**In Response to CURE Requests 1-143  
Application for Certification (08-AFC-5)  
SES Solar Two, LLC**

Subject: SES Solar Two (08-AFC-5)  
Responses to CURE Data Requests 1-143  
URS Project No. 27657106.00400

**SES Solar Two**  
**In Response to CURE Data Requests, Set One**  
**Data Requests 1-143**  
**08-AFC-5**

SES SOLAR TWO LLC  
 SOLAR TWO SITE PLAN  
 TRAFFIC CONTROL PLAN  
 CONSTRUCTION AND OPERATION STAGES

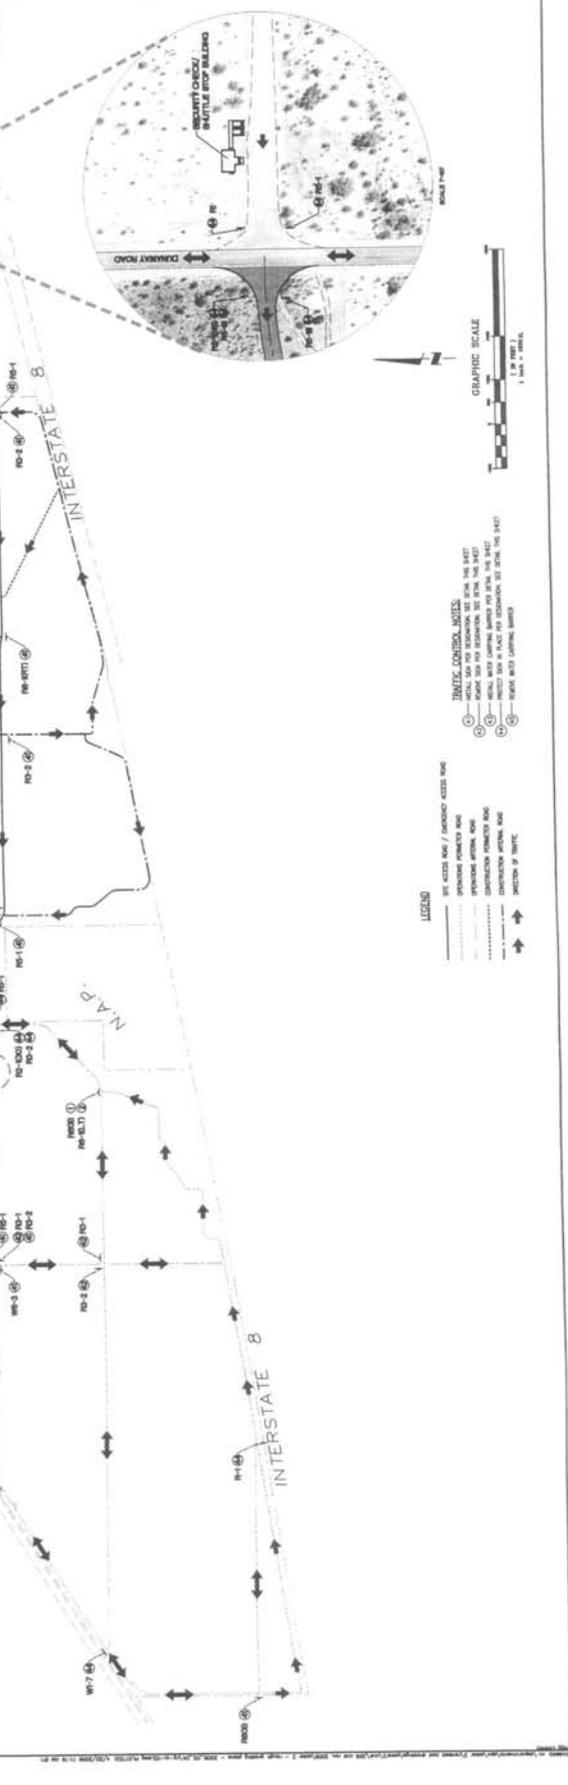
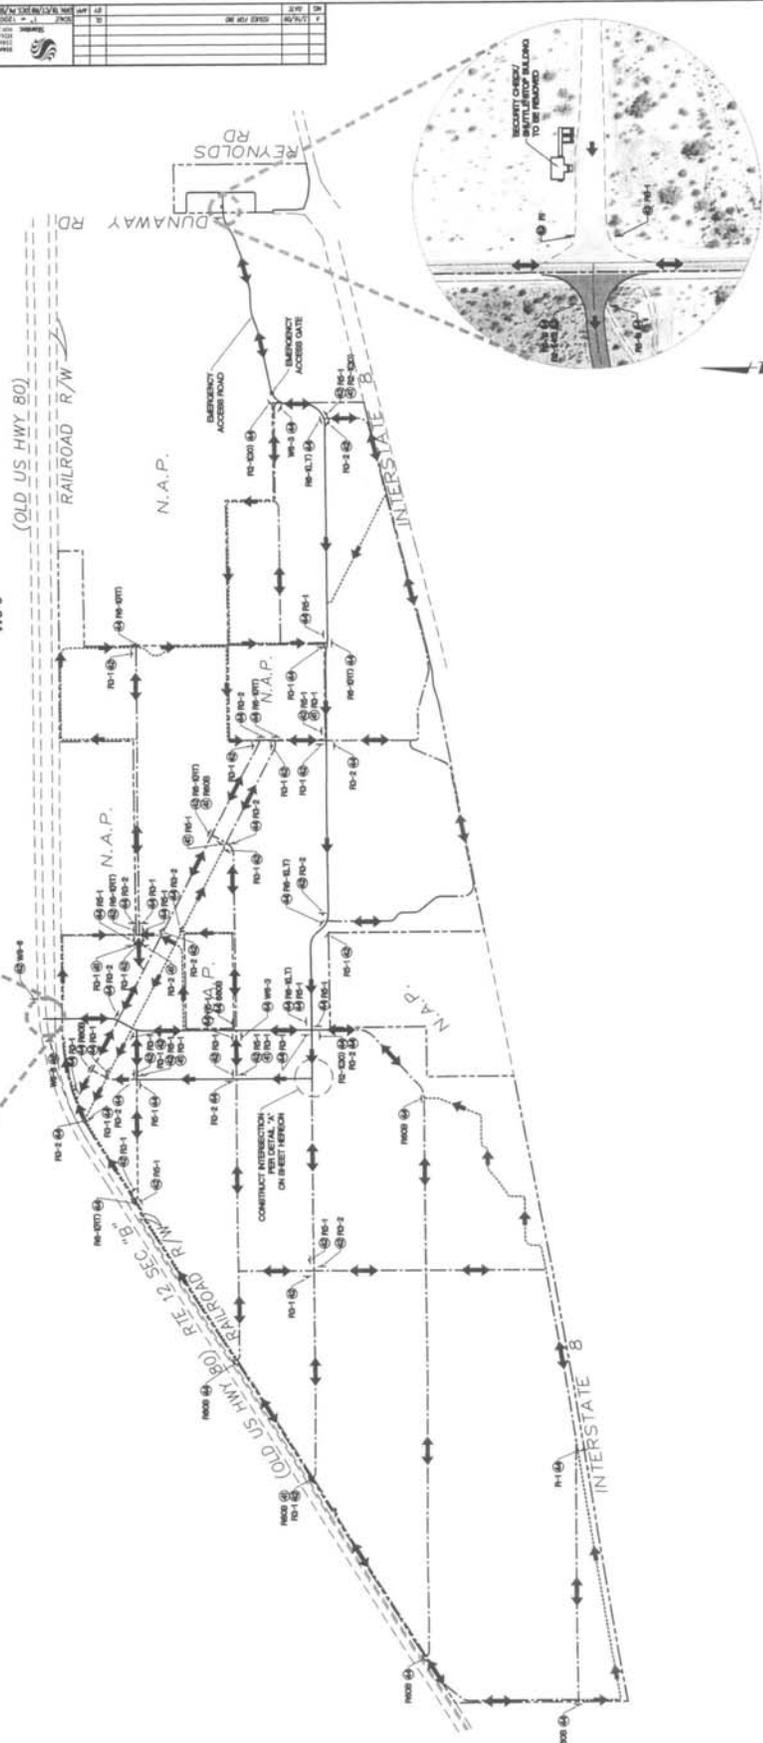
**Data Request 5:** Please identify the level of traffic control that will be required to provide safe traffic conditions at both primary access driveways during Phase I and II of construction, as well as during post construction operating conditions.

**Response:** Traffic control will be primarily in the form of signage and striping and delineation lines and painted pavement markings. The Traffic Control Plan (attachment TRAF-3 provided behind this response) shows the proposed traffic control during both phases of project construction and during post construction operating conditions.

**Response:** As illustrated in the Traffic Control Plan (provided as attachment TRAF-3), the Applicant will install the required measures at the Project access driveways according to Caltrans and Imperial County design standards.

**Response:** The Traffic Control Plan (attachment TRAF-3) show the proposed traffic flow and signing during both phases of project construction and during post construction operating conditions.

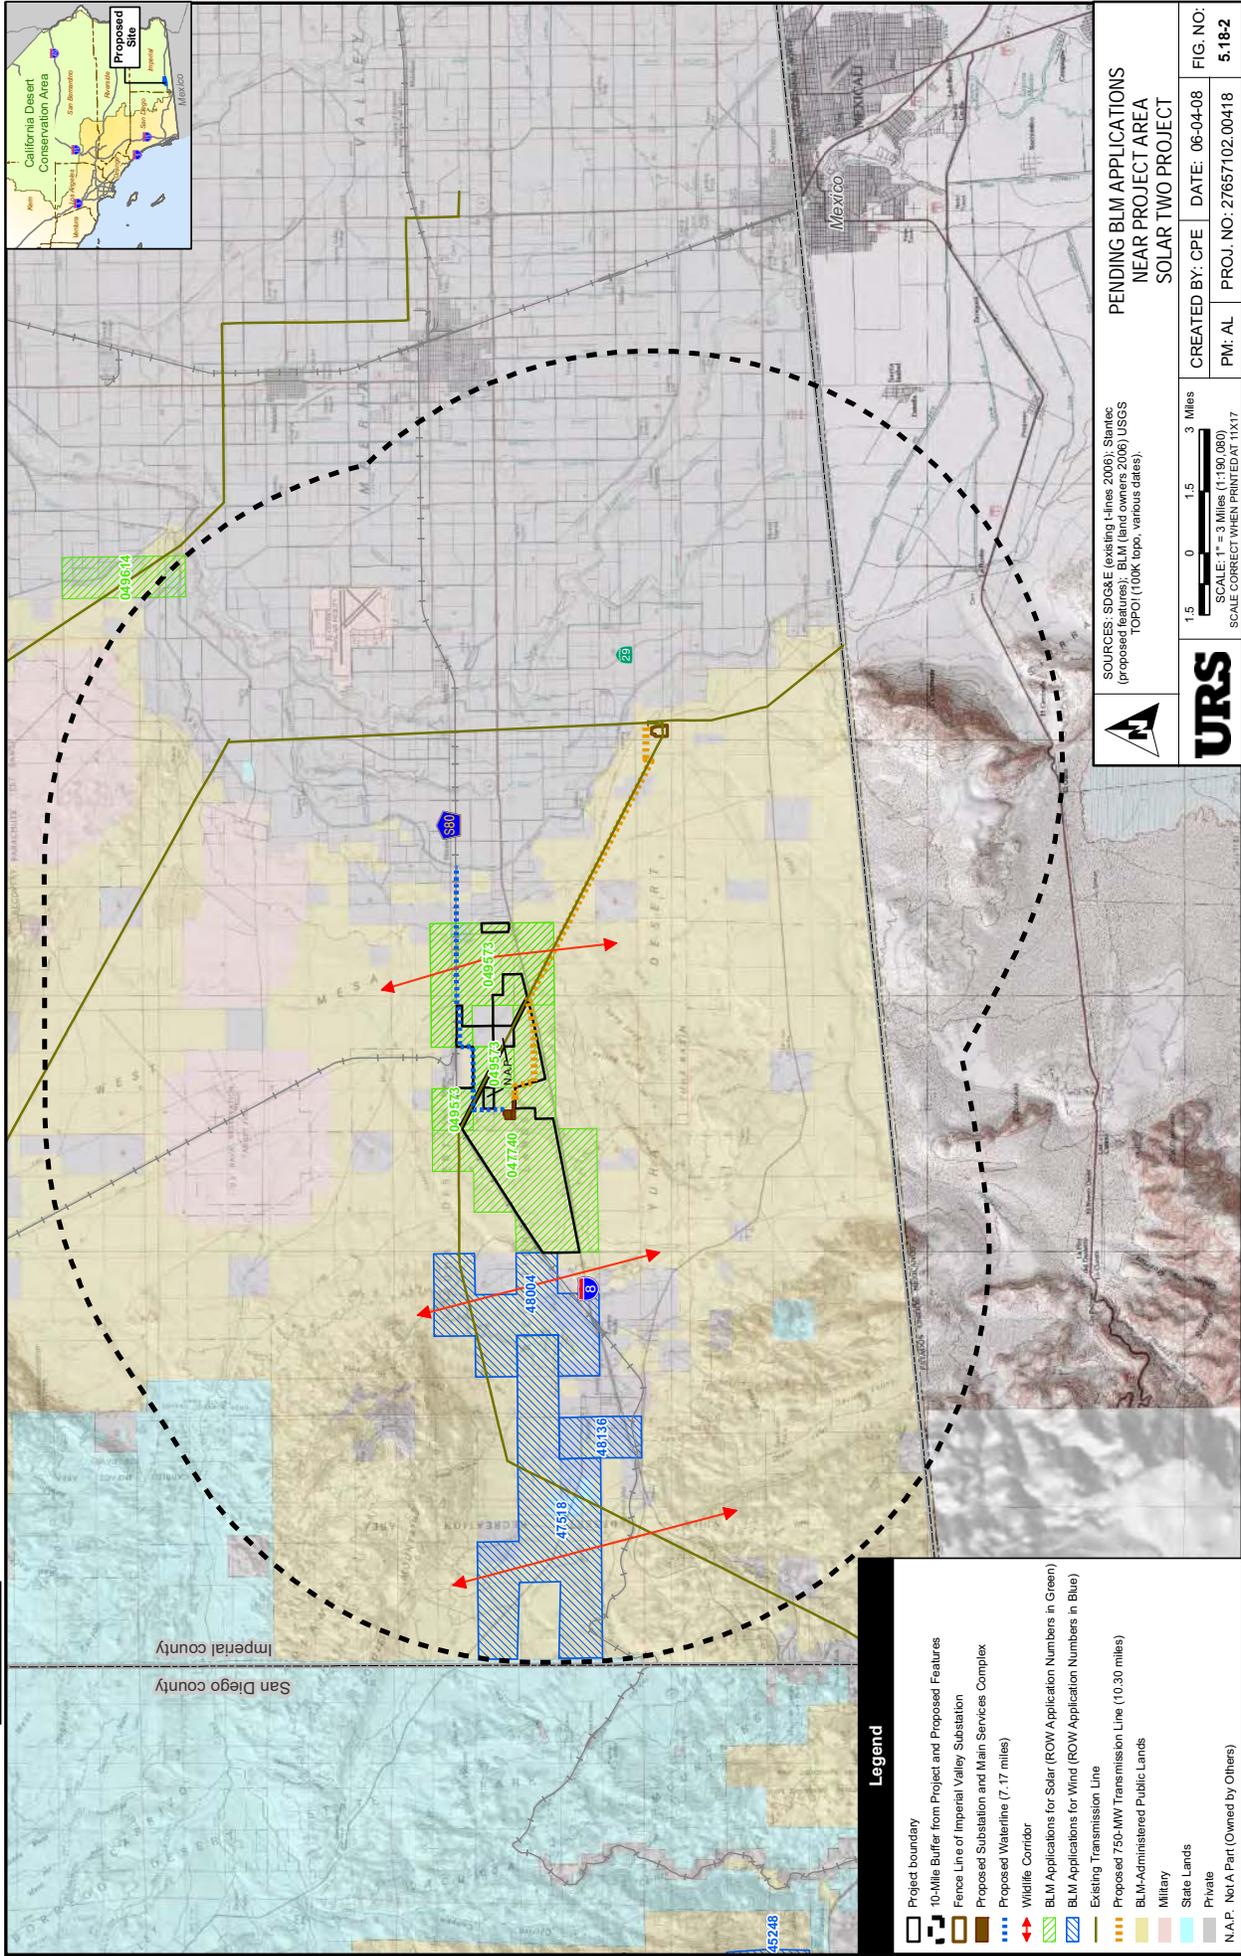
**Data Request 42:** Please provide an analysis of the Project's direct, indirect, and cumulative impacts on wildlife corridors.

**Data Request 43:** Please use the map provided in AFC Figure 5.18-2 to depict the “alternative routes” available to wildlife.

**Response:** The site is not considered an important wildlife corridor because it is bounded by I-8 to the south and S-80 (Evan Hewes Highway) and railroad tracks to the north and west. An area of open habitat will remain intact between the eastern Project boundary and Dunaway Road that could be used as a wildlife movement route. Additional opportunity for wildlife to move north or south of I-8 occurs west of the Project site (please see attachment BIO-1 provided behind this response).

**Response:** See attachment BIO-1, a figure with alternative routes for wildlife movement added to Figure 5.18-2 provided with the response to Data Request 42.
